DATE: May 5, 2021
TO: Planning Commission

FROM: Jane Kansier, AICP, Planning Consultant

SUBJECT: Planning Case # 21-011 – Public Hearing Required
Applicant: Chick-fil-A, represented by HR Green
Property Location: 3855 Lexington Avenue
Request: Conditional Use Permit, Master Plan Planned Unit Development, Final Planned Unit Development

Freestanding Signs

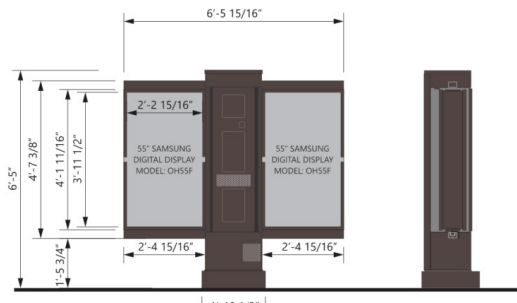
The applicant is proposing to utilize the existing Perkins sign on the north side of the property by changing the sign face. A freestanding sign is also proposed at the corner of Lexington Avenue and Red Fox Road. This sign is 16’ in height and includes 57 square feet of sign area.
